ENGINEERING BULLETIN HT-40

CRYSTAL - VFO CIRCUIT CHANGE

FOR THE HT-40

Illustration A. Modifying Tank Coil L10.

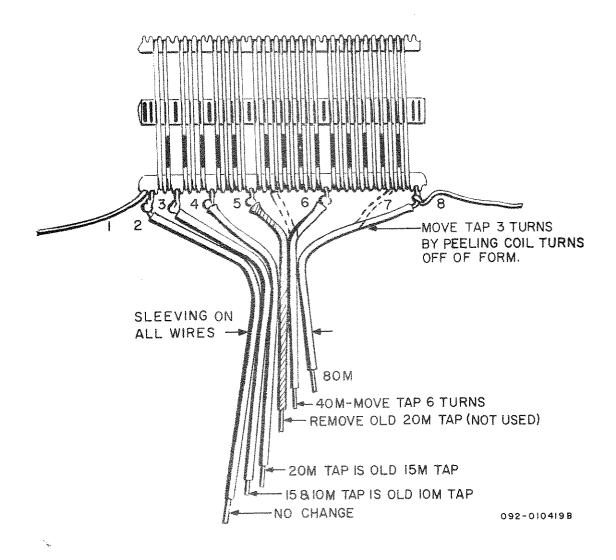
1. The HT-40 final output section was designed so as to minimize the possibility of tuning to a harmonic in any band, i.e., tuning up on 20 when 40 meter operation is desired.

Additional investigation has shown that this feature results in less than optimum suppression of the 2nd, 3rd and higher order harmonics.

A simple modification to the Tank Coil L10 may be made in the field to improve the harmonic suppression as follows:

- a. Remove 3 turns from the 80 meter end of L10 coil.
- b. Unsolder 40 meter tap and move toward 20 meter tap 6 turns (2 turns from 20 meter tap) and solder in place.
- c. Remove lead from the 20 meter tap position on both coil and switch. Contact No. 9 of S2D front.
- d. Unsolder lead from 15 meter tap at contact No. 10 of S2D front and resolder to contact No. 9 of S2D front. (This is now the 20 meter tap, see illustration on reverse side).
- e. Solder a short jumper lead between contacts No. 10 and No. 11 of S2D front. (This is now the 10 meter and 15 meter tap.)

Caution must now be exercised in the tune-up procedure in that 80, 40 and 20 meters will be reached at a point beyond half capacity of the plate tuning and any response near minimum capacity will be tuning the PA to the second harmonic and should be avoided.

Illustration B. Schematic Diagram, HT-40 with Crystal-VFO Wiring Change.

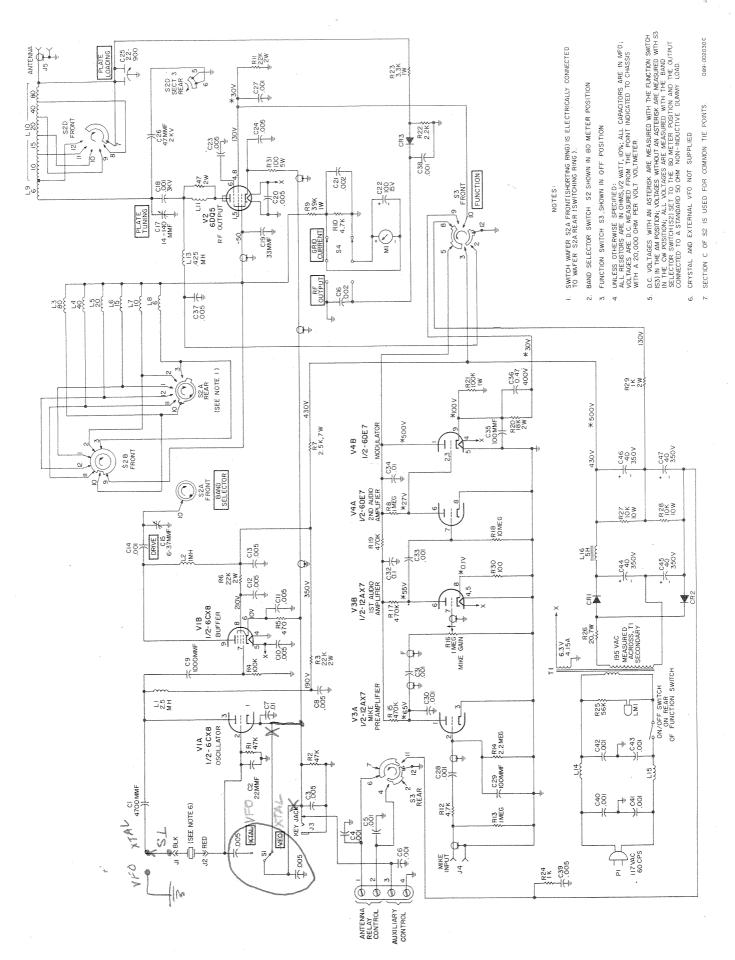
The following change is recommended for improved VFO operation of the

- HT-40. Refer to illustrations B and C when making this change. () Remove the end of the 470 ohm, 1/2-watt resistor, R5, which is connected to terminal 1 on tube socket XV1. () Add a 2-inch length of wire to the free end of this 470 2. ohm resistor, R5, and connect this end to terminal 2 on Terminal Strip TS9. () Remove the yellow wire between terminal 2 on the 3. crystal-VFO switch S1 and the black crystal socket terminal. () Remove the end of the violet wire connected to 4. terminal 1 on tube socket XV1 and connect it to terminal 2 on the crystal-VFO switch S1. () Remove the end of the yellow wire connected to 5. terminal 1 on the crystal-VFO switch S1. Do not disconnect the other end. () Completely remove the black wire connected between 6. terminal 3 on the crystal-VFO switch S1 and terminal 3 on Terminal Strip TS9.

- () Connect this black wire between terminal 1 on tube 7. socket XV1 and terminal 1 on crystal-VFO switch S1.
 - () Remove the end of the green wire connected to the red 8. crystal socket terminal and connect it to the black crystal socket terminal.

- () Connect the free end of the yellow lead removed in Step 9. 5 to the red crystal socket terminal.
 - () Cut both leads of a .005 mfd, 500V, ceramic disc 10. capacitor to 3/4-inch length and install between terminal 3 of the crystal-VFO switch S1 and the black crystal socket terminal.

- 11. () Cut both leads of a .005 mfd, 500V, ceramic disc capacitor to 1/2-inch length and install between terminal 2 and terminal 3 on Terminal Strip TS9.

This completes the crystal-VFO circuit changes and will improve the HT-40 operation when used with a VFO.
